INDEPENDENT EXPERT EVIDENCE ADVICE

WHITEHORSE CITY COUNCIL PLANNING SCHEME AMENDMENT C194

September 2017

Drawing Number: TP122
 Revision: C

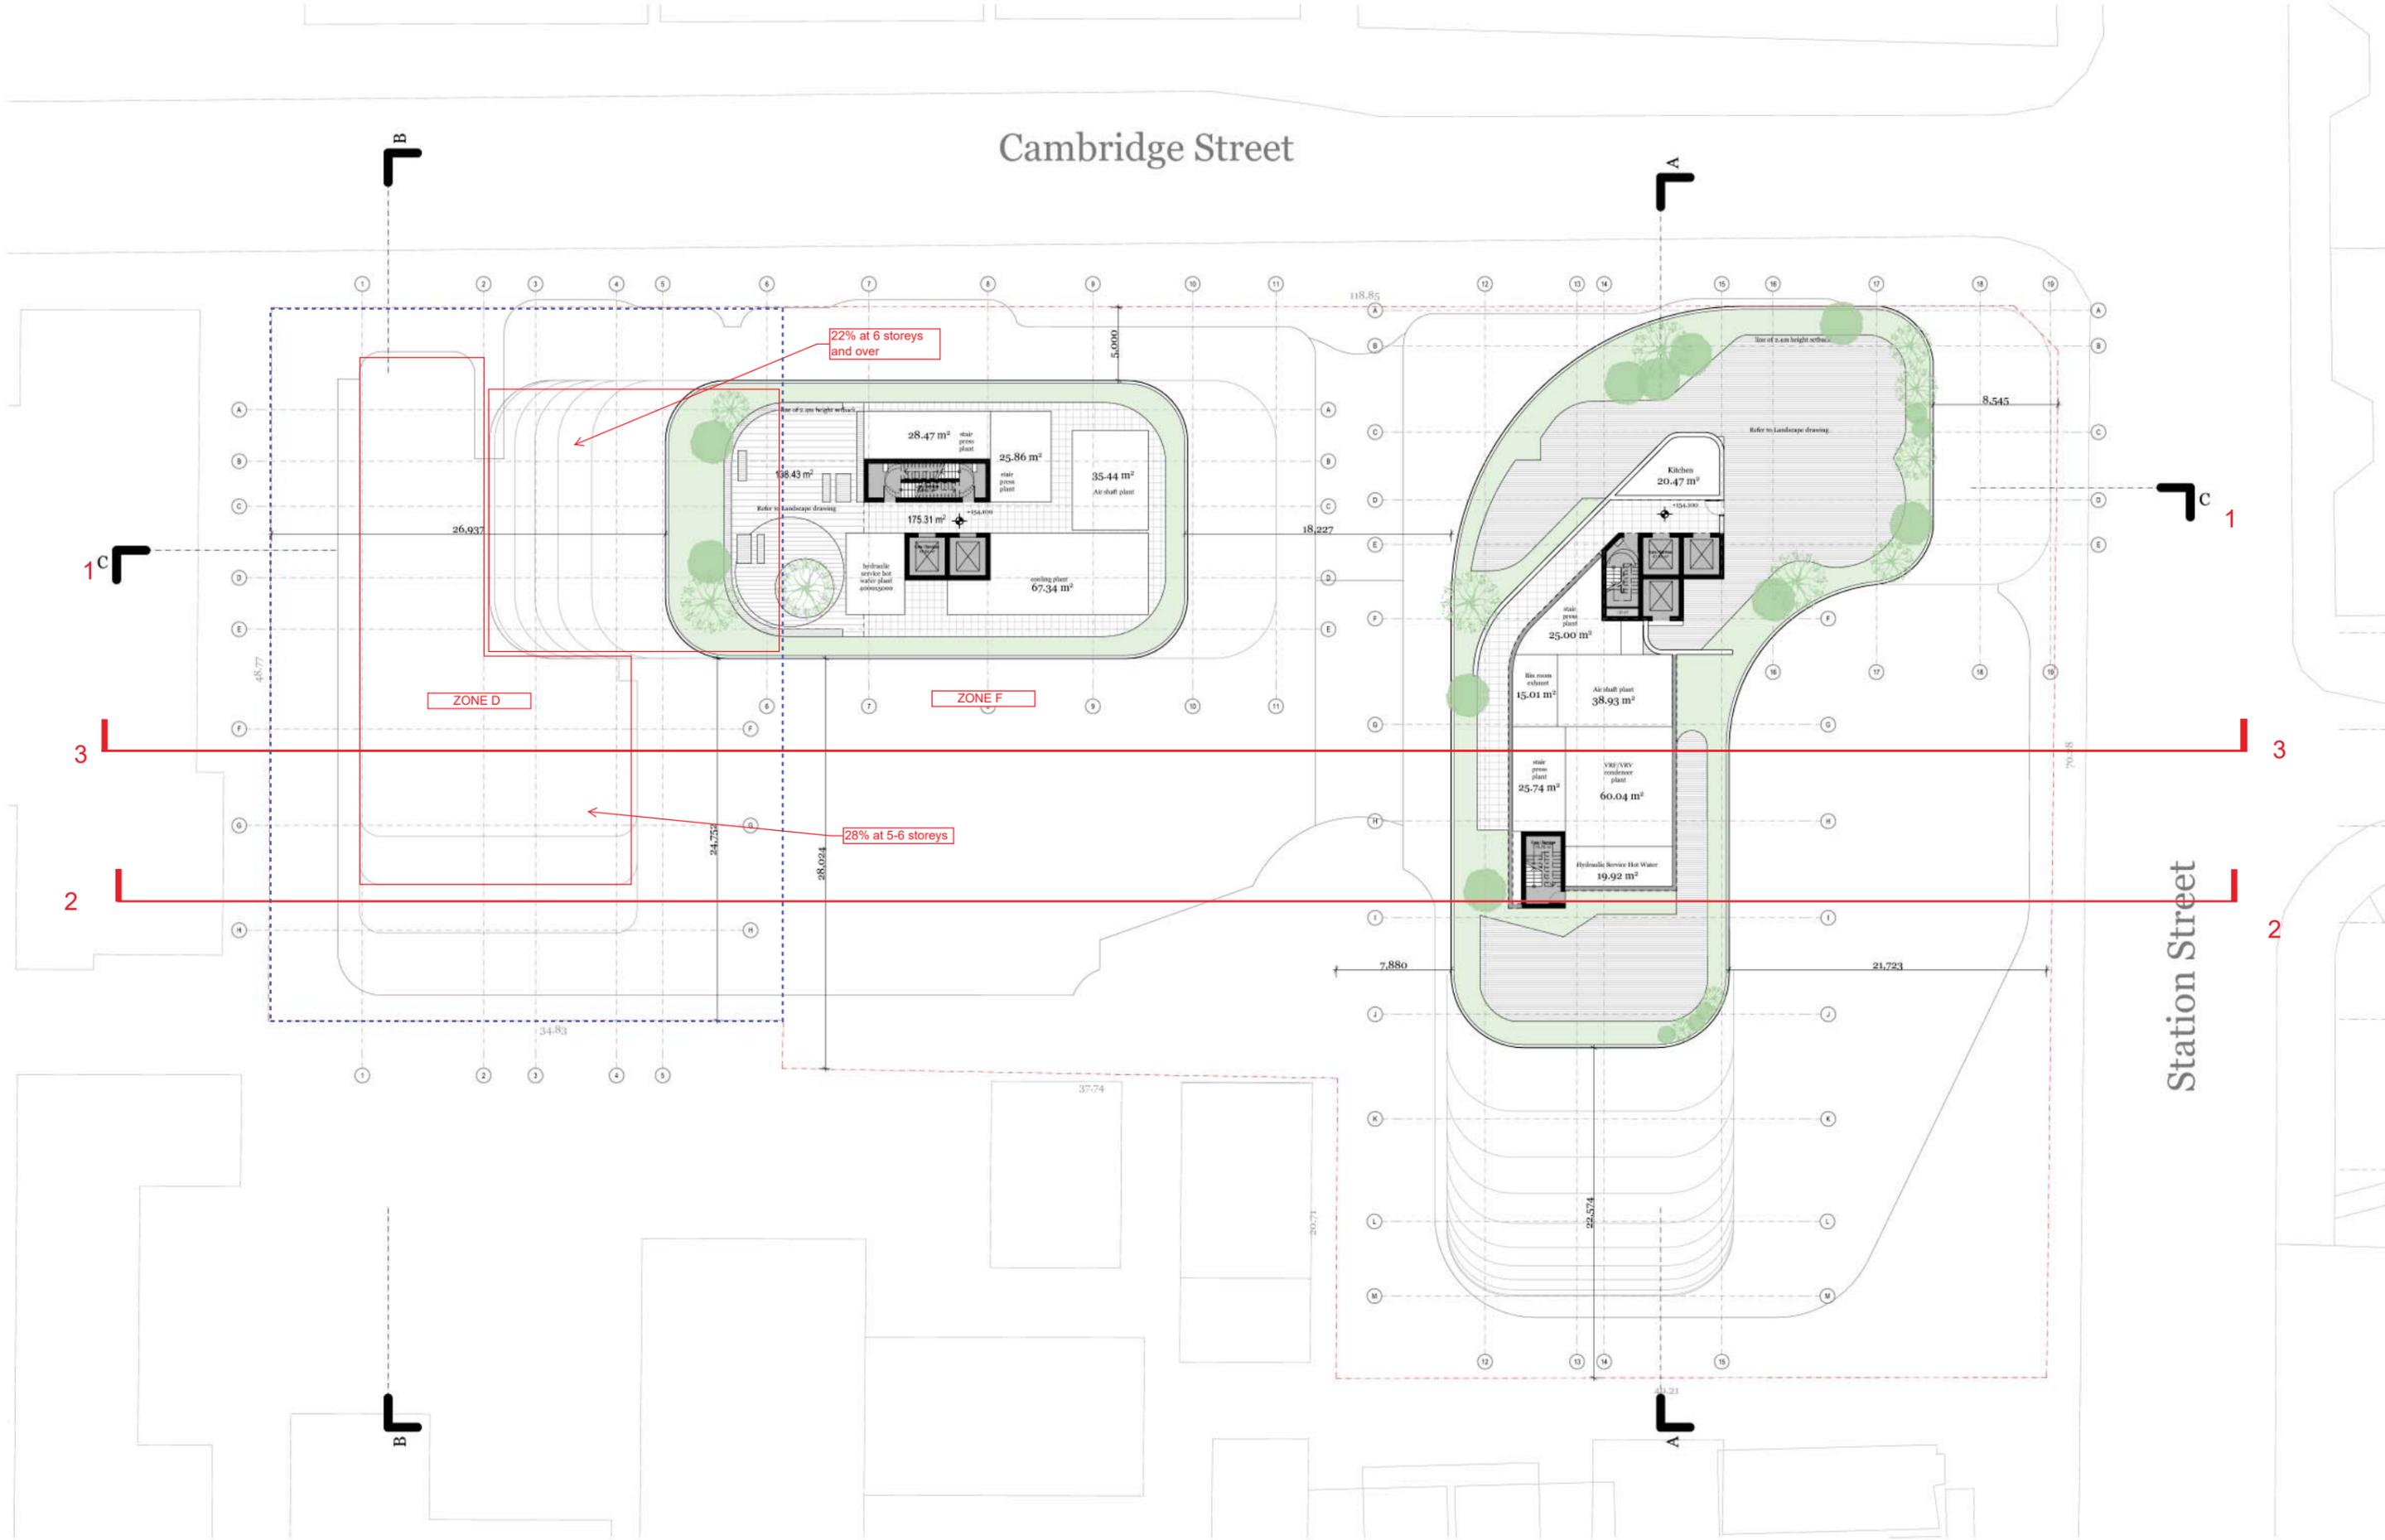
89. While I support the overall height of 6-storeys I would prefer to see a clearer transition to a 'setting back' or recessive form of Building C to the western boundary above Level 4, with a suggested increased distance to boundary of 9m at the parapet of Level 6. I have further illustrated this on Sectional Sketches.

92. To avoid this issue at upper levels where the distance to the neighbouring property's windows is less than 9m screening should be required to 1.7m AFF, or as an alternative a distance of 9m should be accomplished between buildings (existing and new) so as screens can be avoided.

SECTION 1
SCALE 1:500@A3

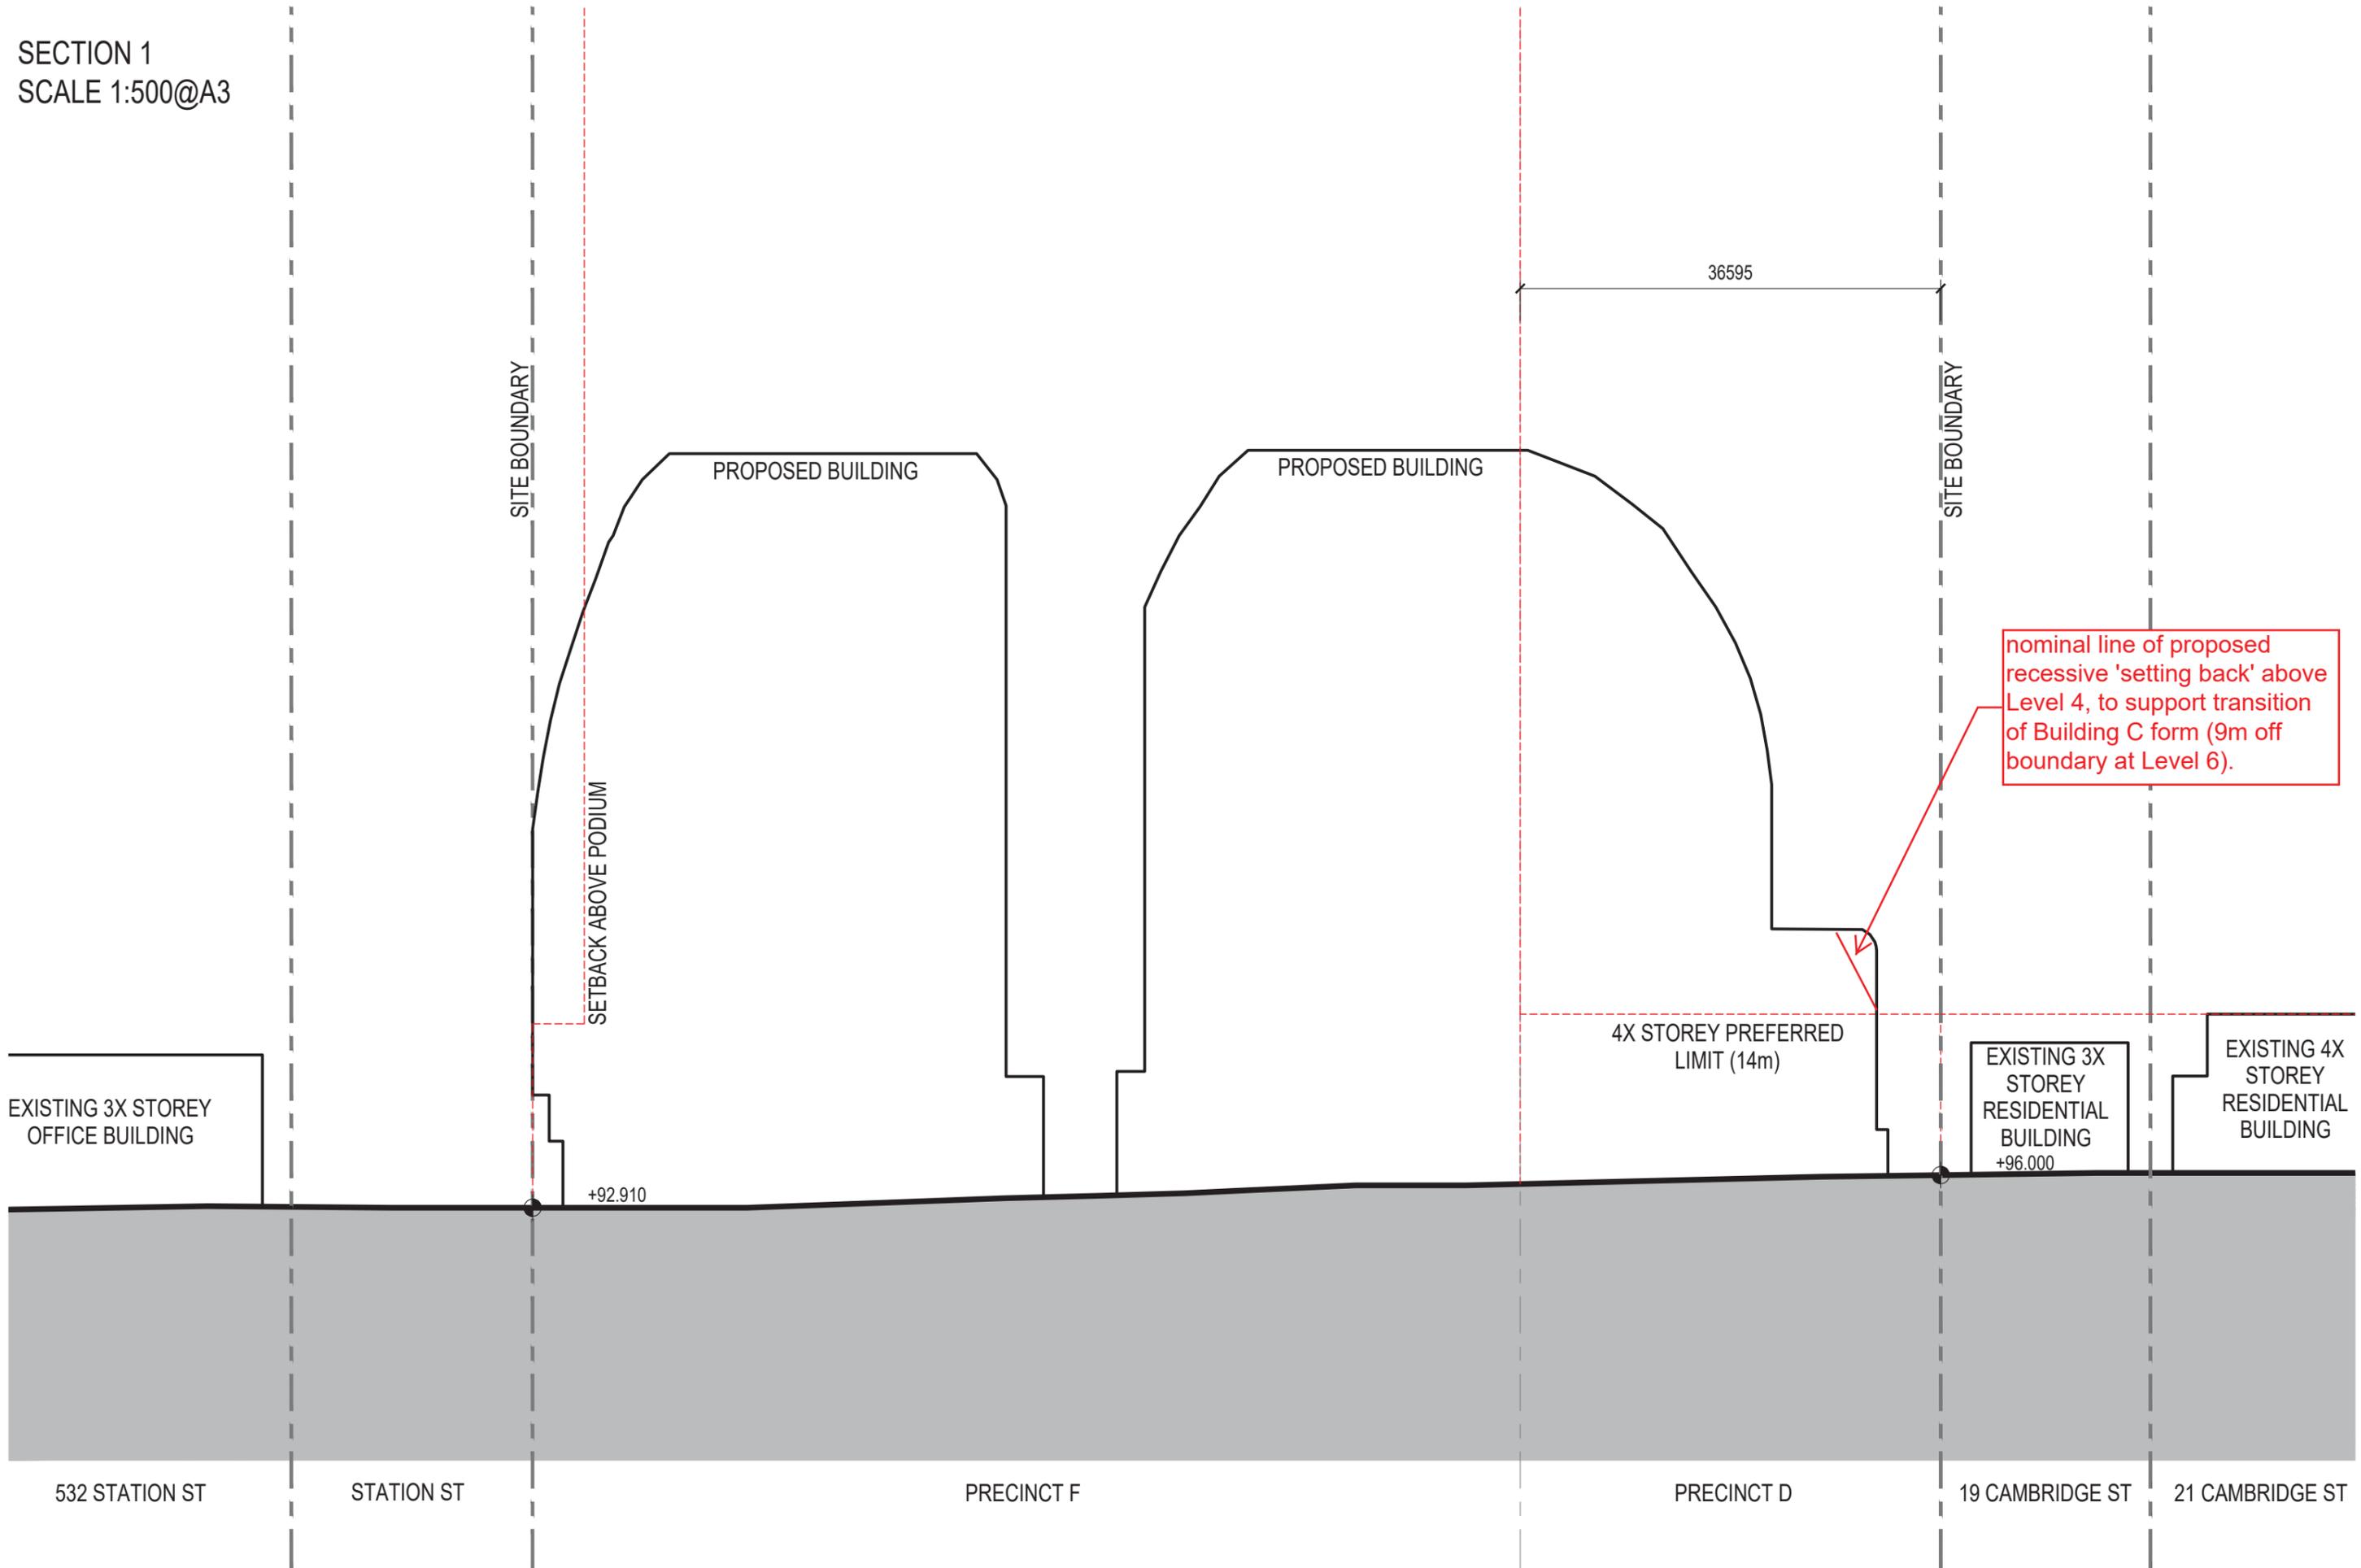
90. The Urbis Report notes that the apartment building to the immediately west is nominally 1.6m off the boundary.
91. Based on this information I am concerned about overlooking issues between existing habitable rooms and the proposed development.
